# City of Albuquerque

**DESCRIPTION OF REQUEST:** Site Development Plan for Building Permit

FILE: **Project # 1001206\***  
07EPC-00246 EPC Site Development Plan-  
Building Permit

LEGAL DESCRIPTION: for all or a portion of Tract 2A2C, **Black Ranch**, zoned SU-1 for C-1 Permissive, located east of COORS NW, between PASEO DEL NORTE NW and IRVING NW, containing approximately 2 acres. (C-13) Anna DiMambro, Staff Planner

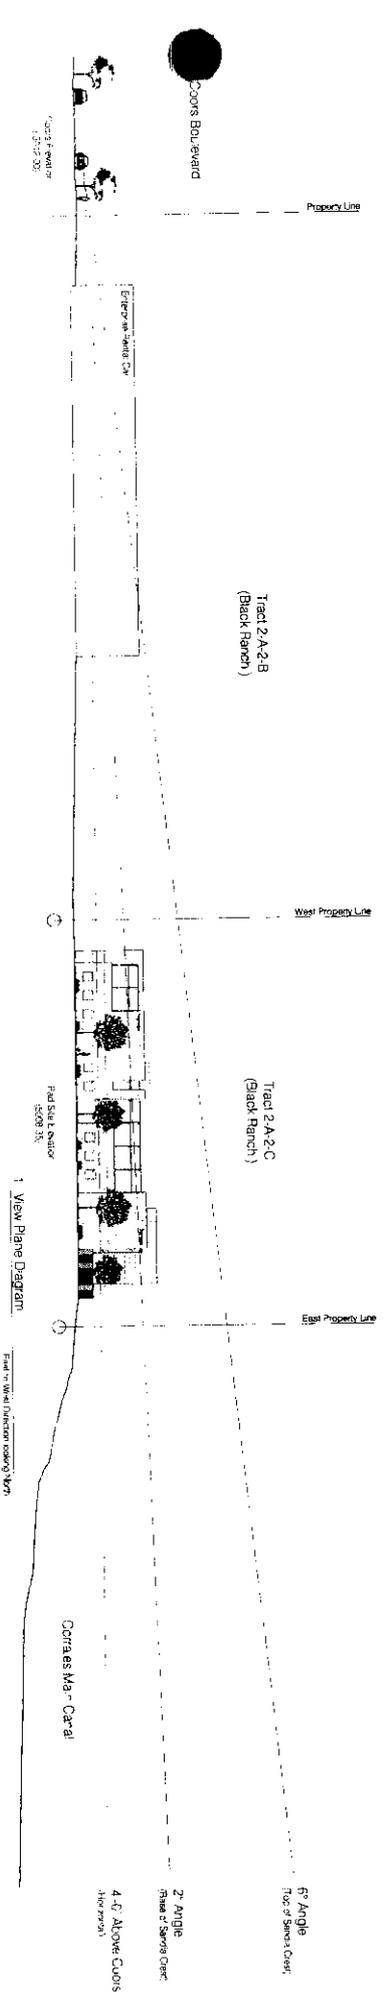
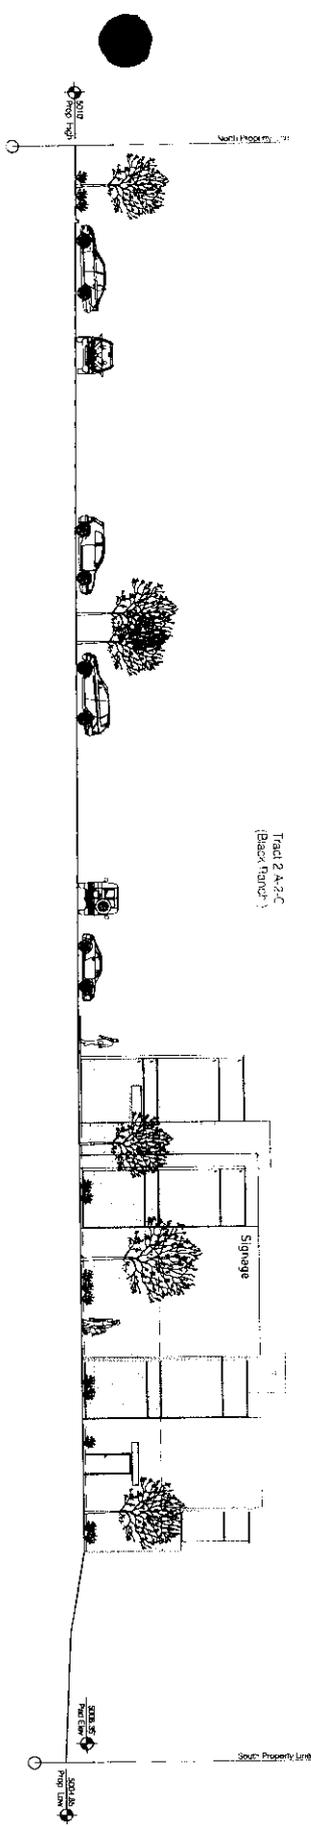
The approved Site Development Plan for Subdivision dated March 25<sup>th</sup>, 2002 allows a maximum building height of 32 feet while adhering to the Coors Corridor View Regulations. The proposed maximum building height is 32 feet at minimal locations. The majority of the building parapets are between 26 & 28 feet, the intent is to provide a building adequate for reasonable mechanical screening as well as to provide comfortable floor to floor heights at its interior.

We respectfully request that the EPC review and approve our proposed building heights & location. These parameters should be acceptable as we are meeting all Zoning & Building Code requirements as well as the Coors Corridor View Regulations with this proposal. We believe the proposed project exceeds expectations and will be a positive addition to Albuquerque's Westside.

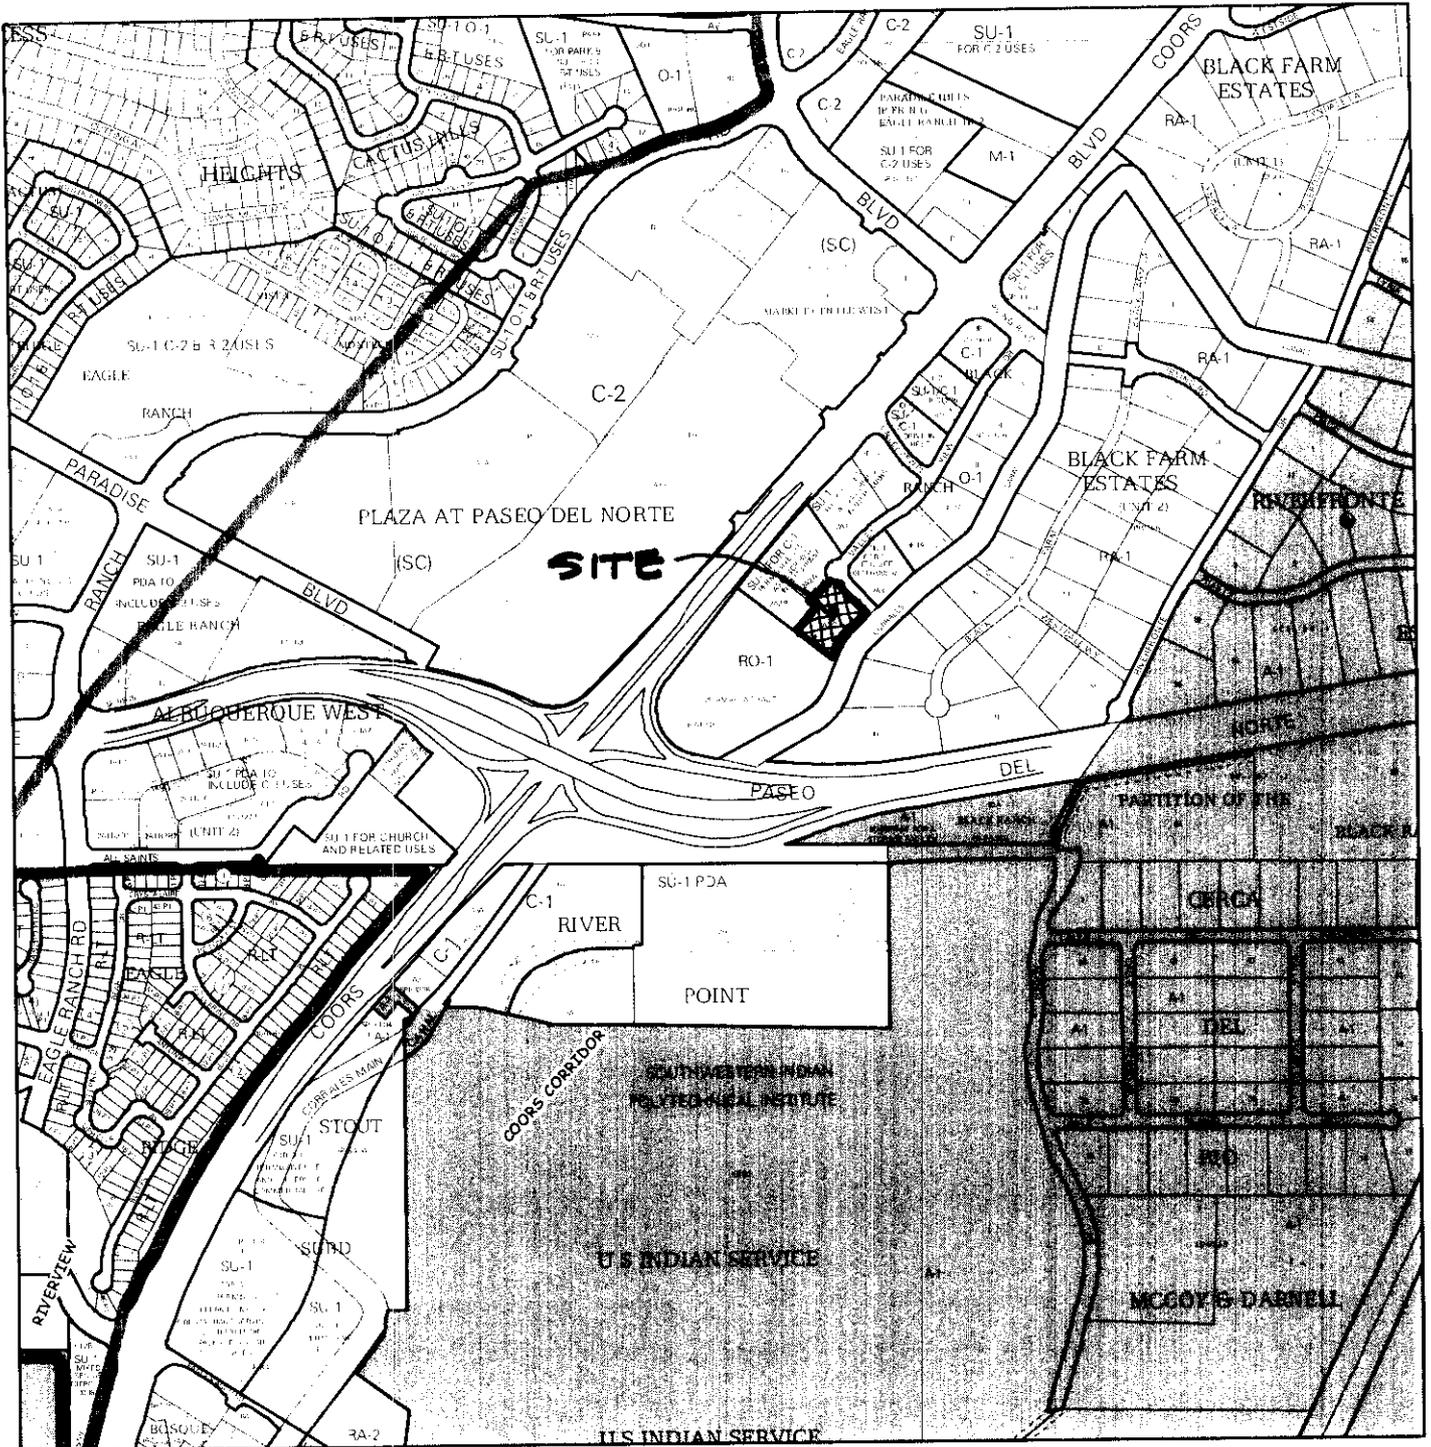
- Show groundcover calculations.  
*Groundcover calculations have been added to Sheet L1.*
- Graphic scale is incorrect (on almost all pages)  
*Graphic scale has been corrected on Sheet AS.01 and AS.03.*

- Spelling error on landscaping plan (Autumn Joy).  
*Spelling error "Autumn Joy" has been corrected on Sheet L1.*
- Re-label sheet AS.01 Site Plan for Building Permit.  
*Sheet AS.01 has been re-labeled as "Site Plan for Building Permit".*

**CONCEPTUAL GRADING PLAN**

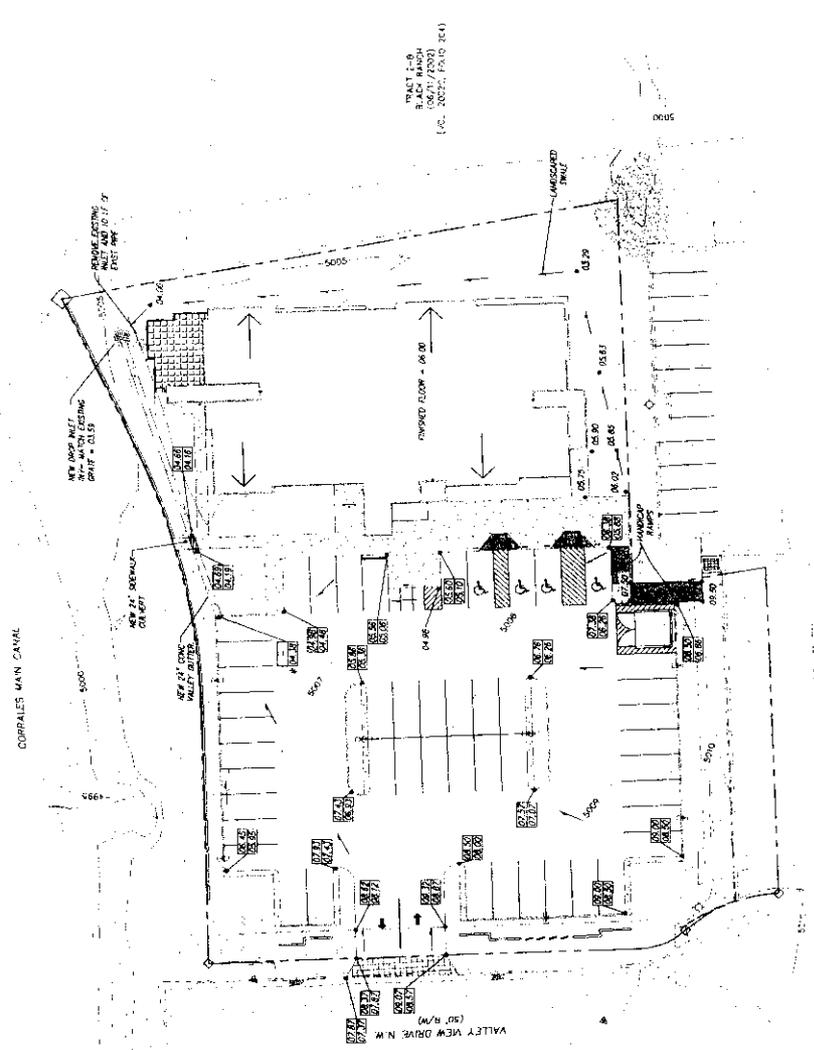
- Spelling error on grading plan in bottom left corner.  
*Spelling error "maintained" will be corrected on the grading plan, Sheet C1, prior to DRB submittal.*
